## Service Bulletin

Passenger Seat Harness Slider Cover

Document: Service Bulletin SB-GA8-2008-43,  
Issue 2

**Figure 1: Correct assembly of the Slider Assembly Part Number 504802-403-142**

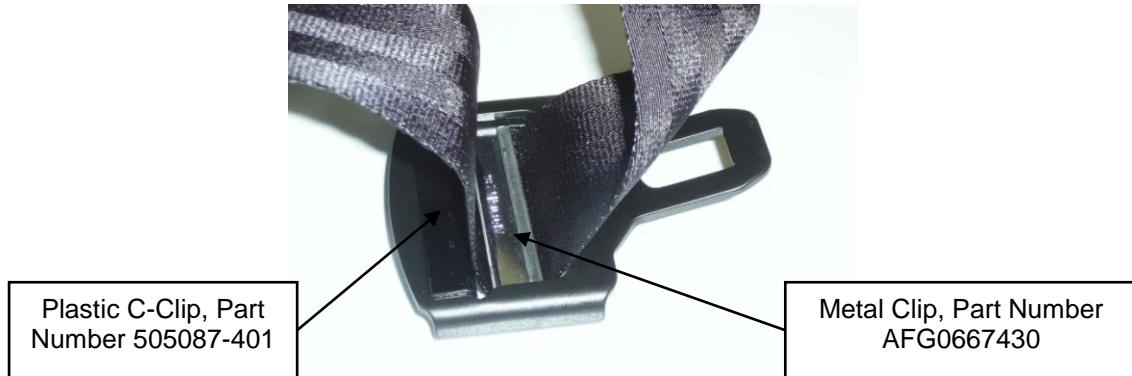
- 1.1. Ensure the metal clip, labelled with part number AFG0667430, and the plastic C-clip, part number 505087-401, are installed correctly in the Slider Assembly. See Figure 1.
- 1.2. Install the cover over the harness clip by aligning and applying firm pressure to snap the cover in place. See Figure 2 and Figure 3.
